From: April Abate
To: mdavis@archcoal.com
CC: OGMCOAL@utah.gov
Date: 4/21/2009 10:24 AM
Subject: SUFCO water quality reports for 2008
Place: OGMCOAL@utah.gov
Attachments: 0007.pdf; 0004.pdf; 0005.pdf; 0006.pdf; April Abate.vcf

WATER QUALITY MEMORANDUM Utah Coal Regulatory Program

TO: Internal File
THRU: Jim Smith, Permit Supervisor
FROM: April A. Abate, Environmental Scientist II ^{COO}
RE: 2008 Fourth Quarter Water Monitoring, Canyon Fuel Company, LLC, SUFCO Mine, C/041/0002, WQ08-4, Task ID #3211
4-13-2009

SUFCO Water Levels Well 01-8-01

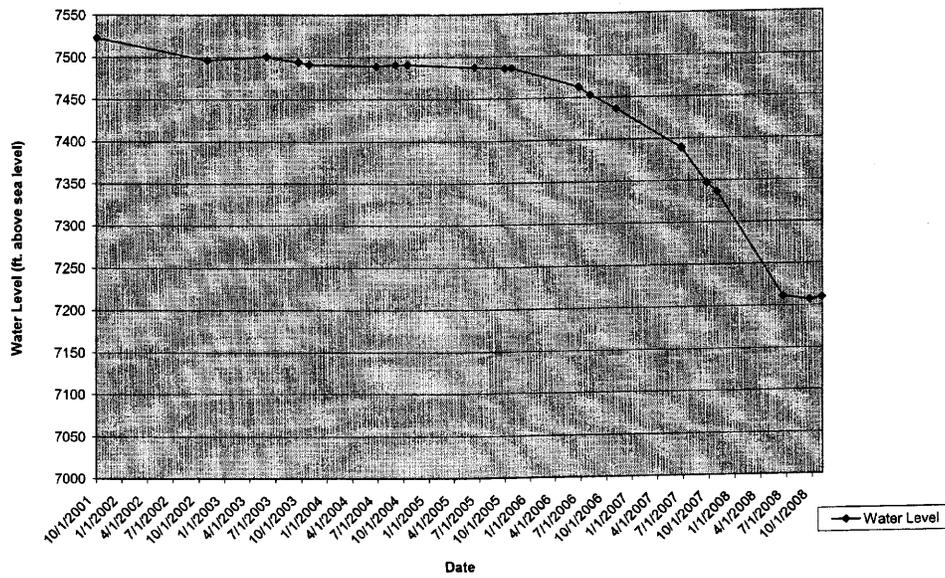
Previous reports have chronicled a decline in water levels at Well 01-8-1 since SUFCO first began to monitor it in 2001. This well is screened in the Upper Hiawatha coal seam, the actively mined seam. As can be seen on the attached graph, a water level drop of approximately 275 feet was evident from the period between October 2005 and June 2008. Water levels appear to be equilibrating based on the past 3 rounds of data collection. Most other wells monitored at the SUFCO mine dropped less than 10' over a period of ten or more years. This is an expected result of underground coal mining, and water levels will equilibrate when mining is ceased.
